TECHNICAL SERVICE BULLETIN

5.0L - Oil Leaks From Valve Cover Gasket

19-2260
28 August 2019

Ford 2015-2017 Mustang

Figure 1

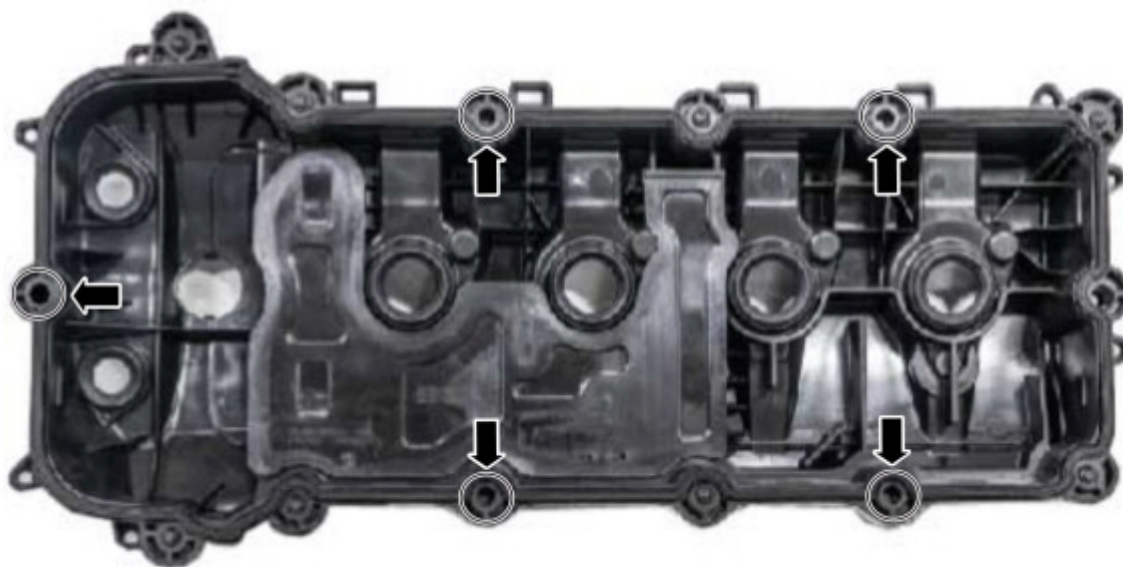
2. Using a 10 mm (0.394 in) drill bit and drilling from the underside of the valve covers, drill holes through the 5 tabs along the perimeter of the valve covers that do not already have holes. This will allow fasteners to go through them. Use the indented area on each tab as a guide to center the drill bit to make sure the holes are drilled in proper alignment to allow fasteners to pass through them and thread into the corresponding holes in the cylinder head when the valve covers are reinstalled on the engine. (Figure 1, right side shown, left side similar)

Figure 2

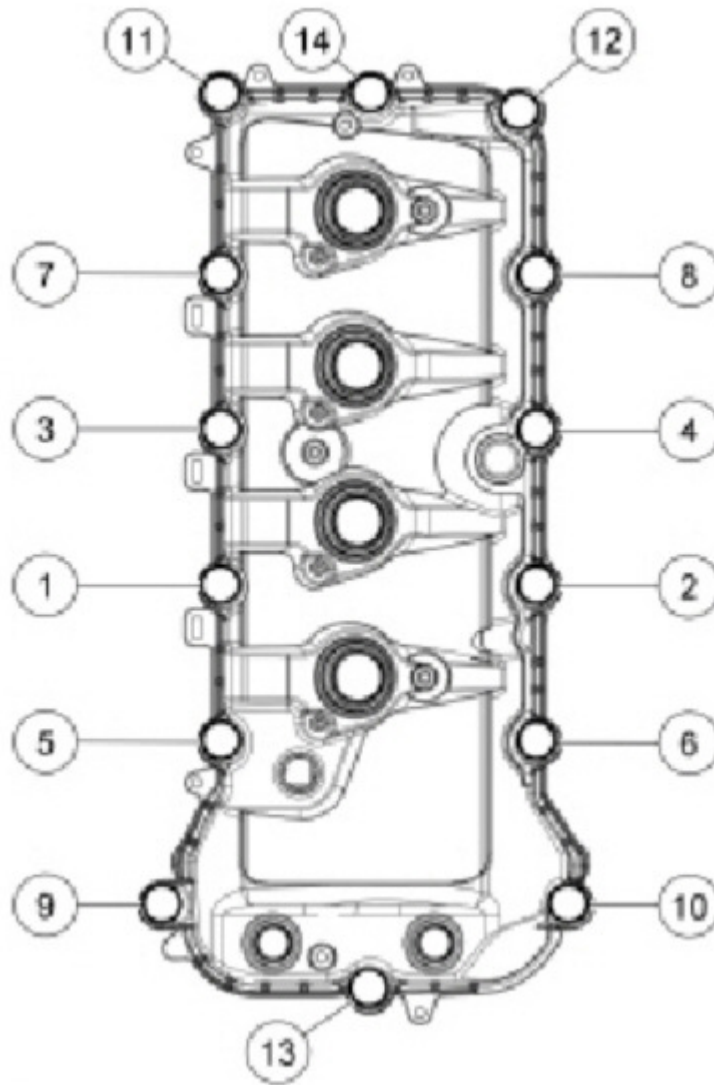
3. Reinstall the valve covers onto the engine, adding fasteners through the holes drilled in Step 2. Refer to WSM, Section 303-01C. Follow the revised tightening sequence in Figure 2 for the left valve cover and Figure 3 for the right valve cover. Tighten the fasteners to 10 Nm (89 lb-in).
